USB Power Delivery ENGINEERING CHANGE NOTICE

Title: Clarify EPR Entry Process

Applied to: USB Power Delivery Specification Revision 3.1

Version 1.8

(c). Figure 6-33, P.186

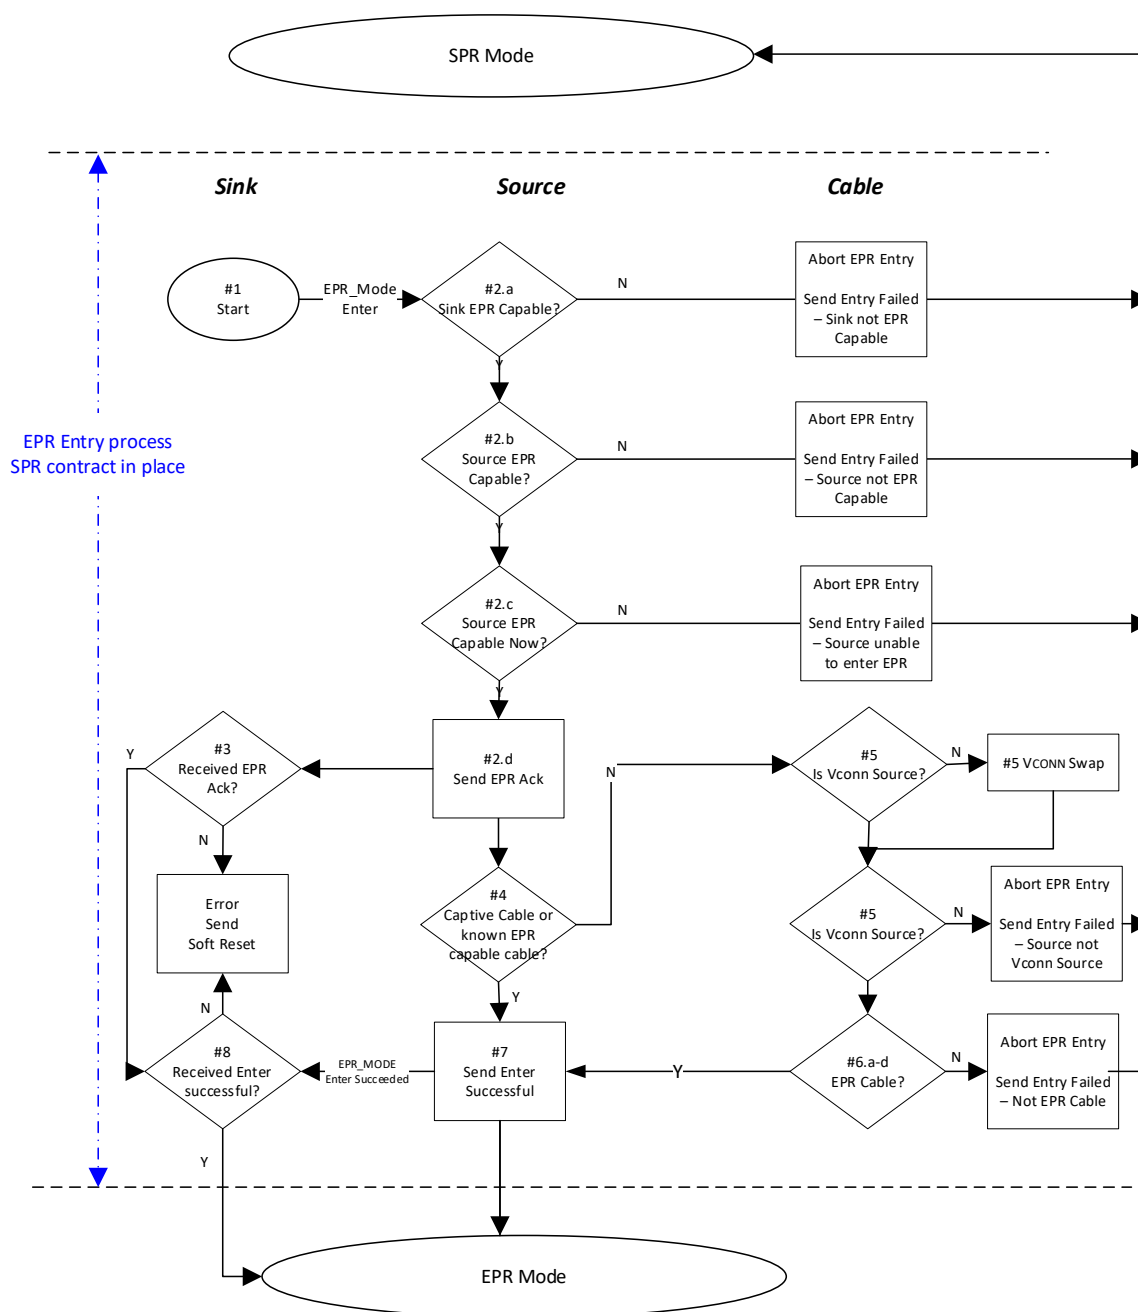
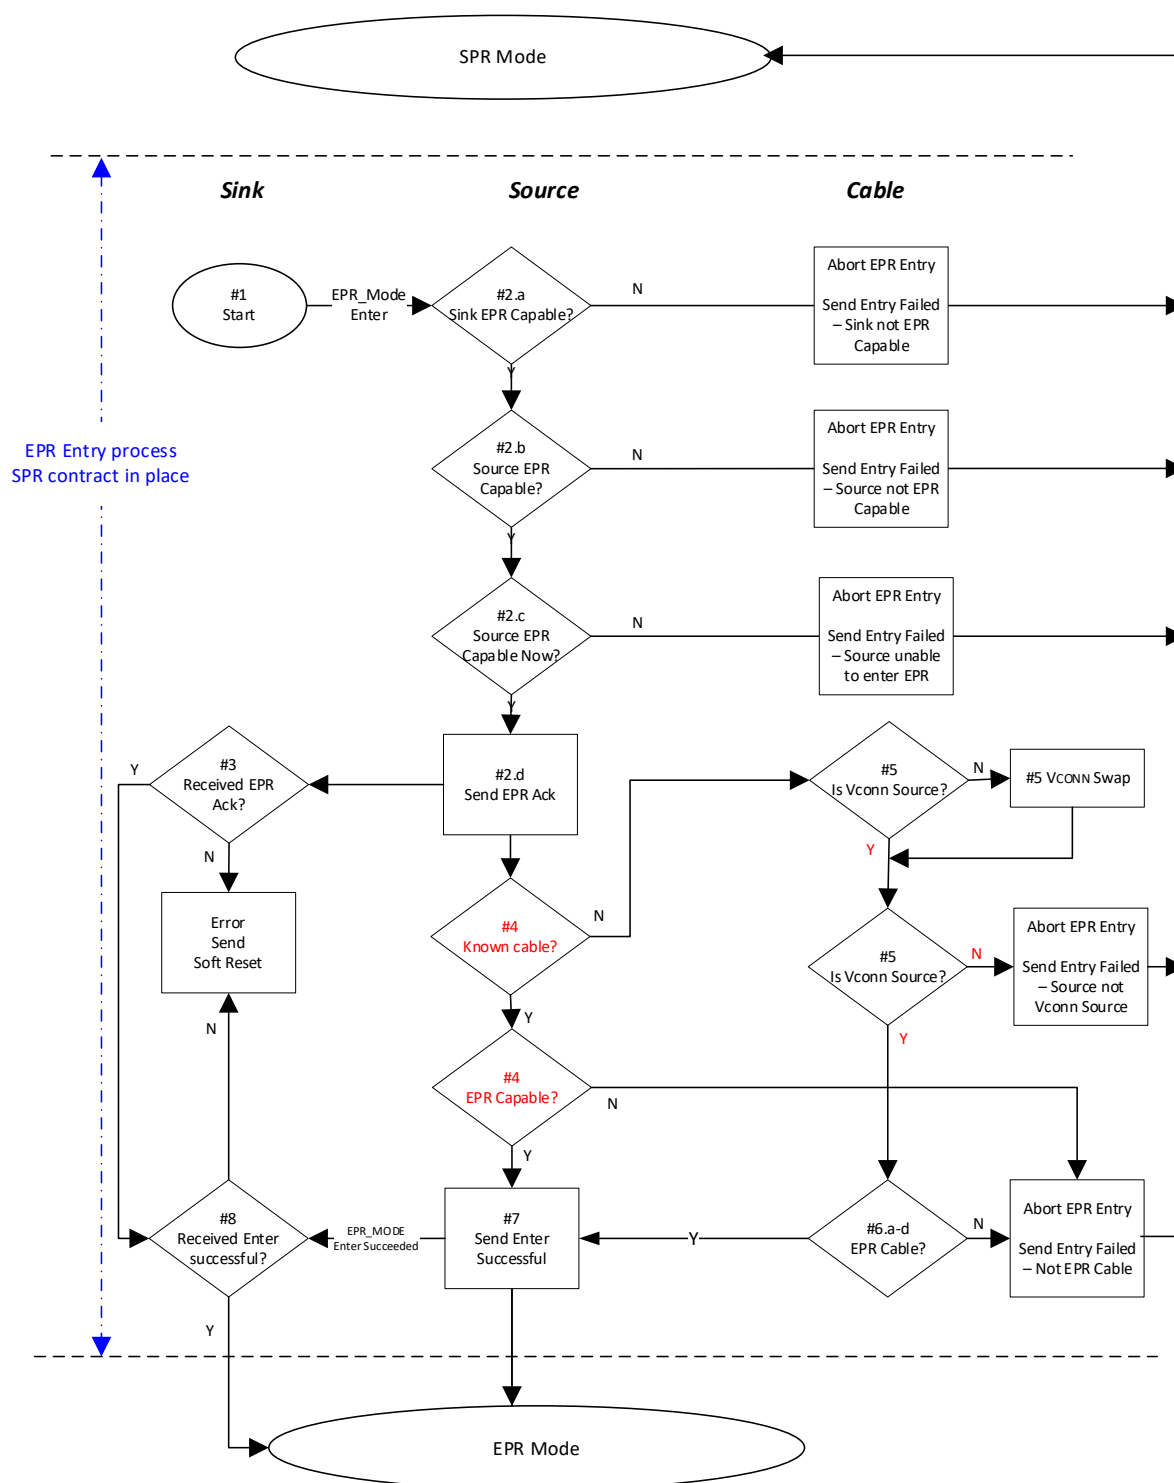
Figure 6-1 Illustration of process to enter EPR Mode

Figure 6-2 Example EPR Mode Entry process
